STAFF REPORT
COMMUNITY DEVELOPMENT DEPARTMENT

SUBJECT: H-2020-0088
Baraya Subdivision No. 5

I. PROJECT DESCRIPTION

Final Plat consisting of 61 building lots and 10 common lots on 12.38 acres of land in the R-15 zoning district for the fifth phase of Baraya Subdivision.

C. Final Plat (date: 9/22/2020)

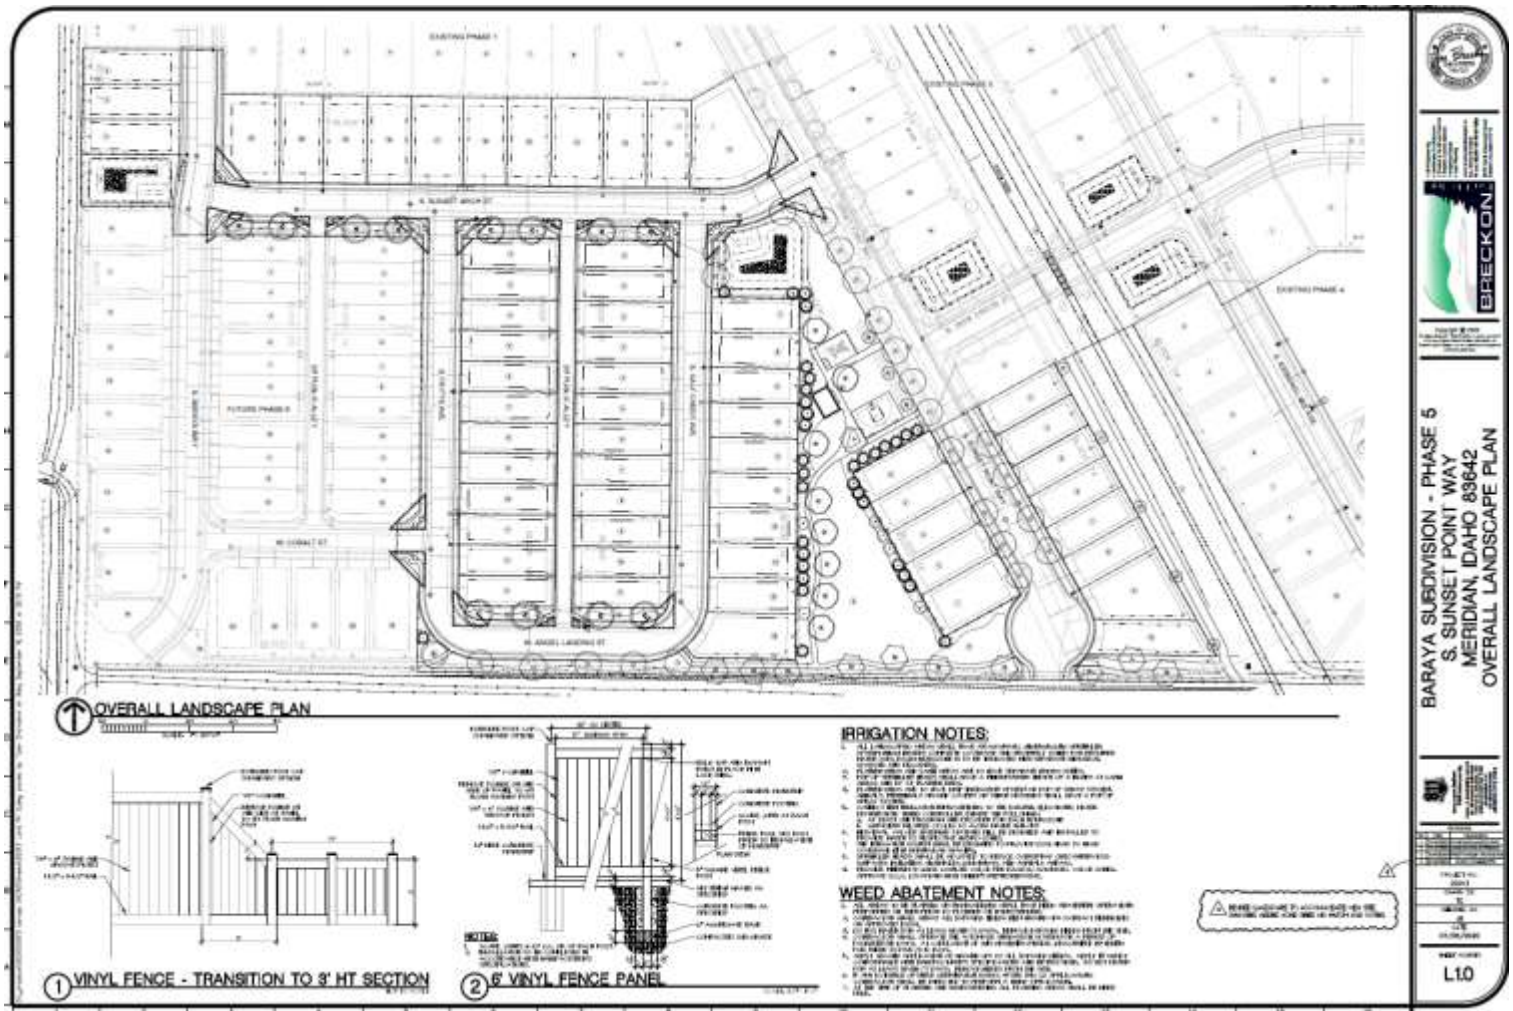
3. Prior to submittal for the City Engineer's signature, have the Certificate of Owners and the accompanying acknowledgement signed and notarized.
4. The final plat prepared by Bailey Engineering, Inc. stamped on 9/22/2020 by Gregory G. Carter, shall be revised as follows:

- a. Note #2: ". . . Lot ~~40~~11, Block 14, Lot ~~7~~6, Block 16 . . ."
 - b. Note #3: ". . . Lot ~~7~~6, Block 16 . . ."
 - c. Note #9: Include the recorded instrument number for the NMID pump station operation and maintenance agreement.

- d. Note #10: Include the recorded instrument number or the ACHD License Agreement.
 - e. Note #11: Include the recorded instrument number for the ACHD Permanent Easement.

- f. Note #14: "Lot ~~40~~11, Block 14 contains a blanket easement . . ."
 - g. Note #15: Include the recorded instrument number of the pathway easement.

E. Approved Preliminary Plat/Open Space (2007) vs. Reconfigured Layout/Open Space (2020)

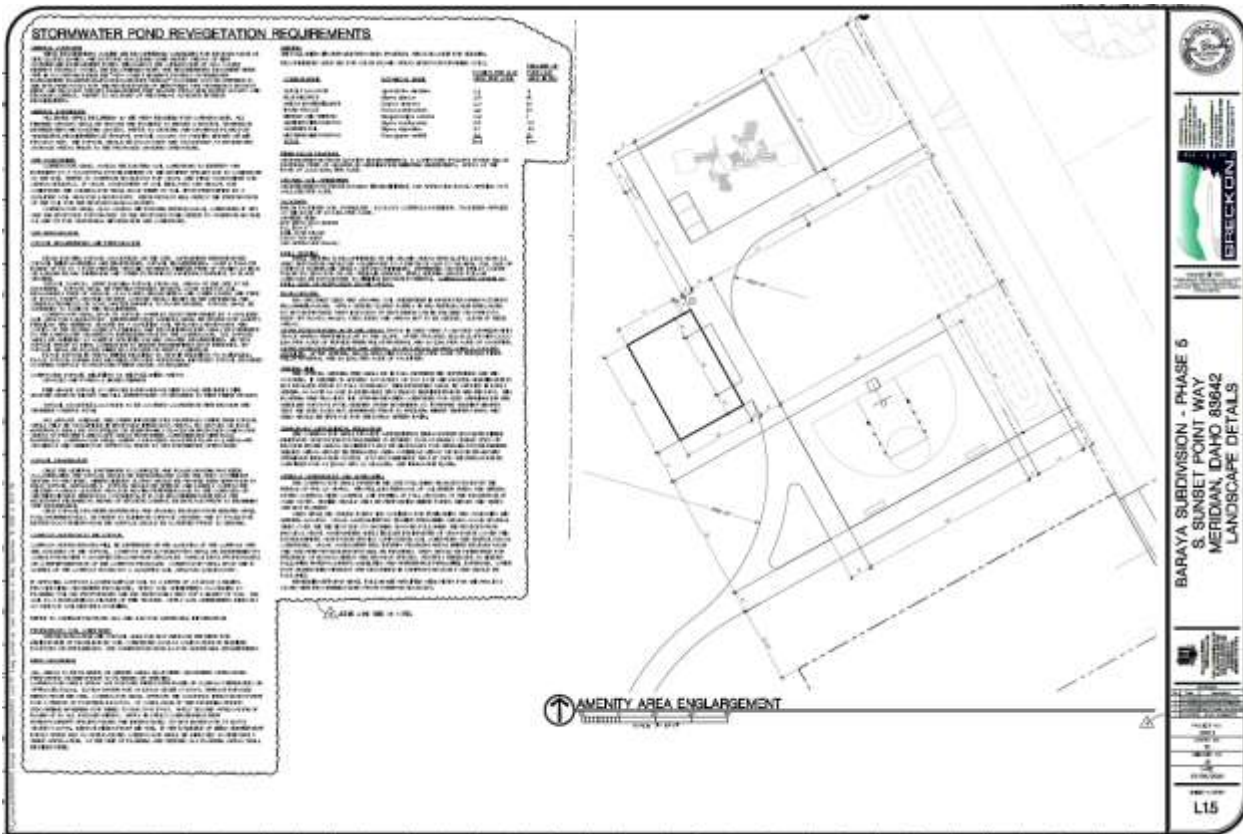
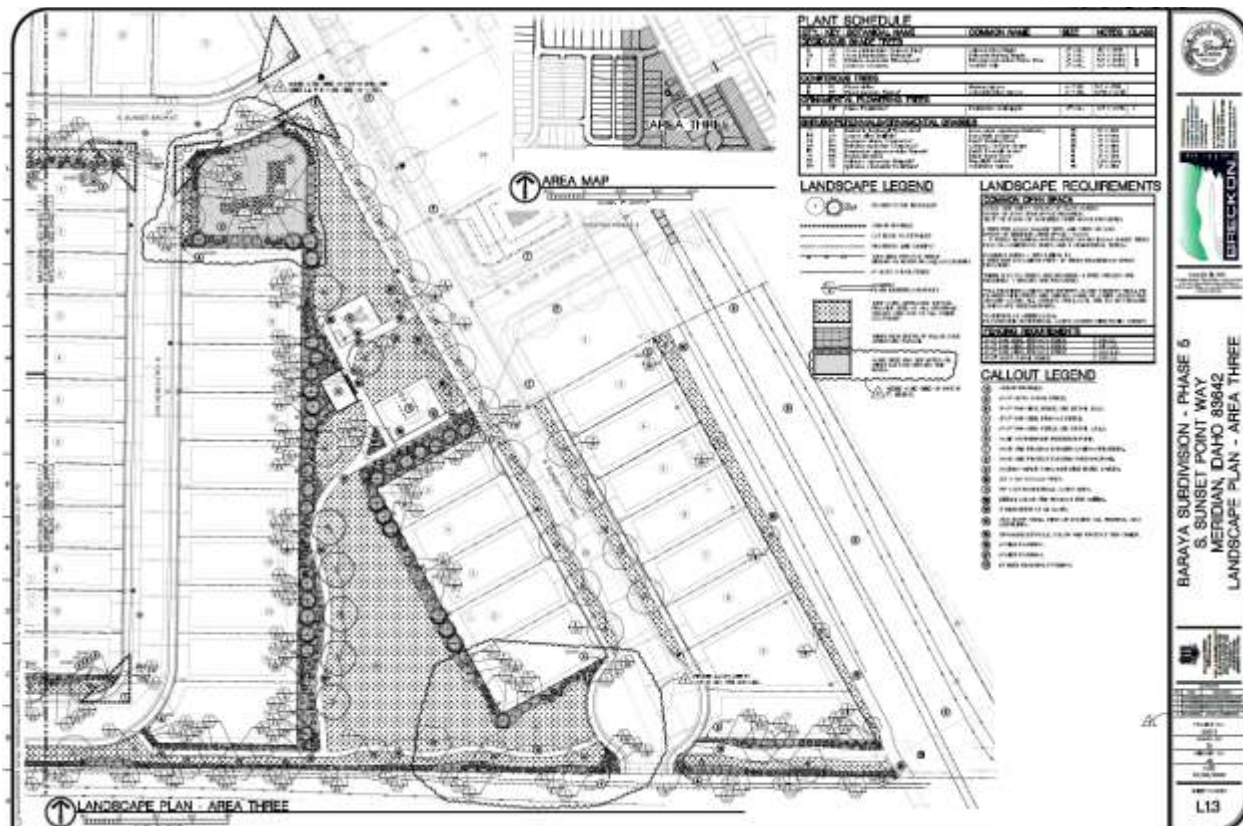
Overall, based on the exhibits in Section V.E, the number of building lots stayed the same as originally approved (i.e. 334) and the amount of common area increased from 11.34 acres (or 17.5%)

to 12.19 acres (or 18.8%). Therefore, Staff finds the final plat in substantial compliance with the approved preliminary plat in accord with UDC 11-6B-3C.2.
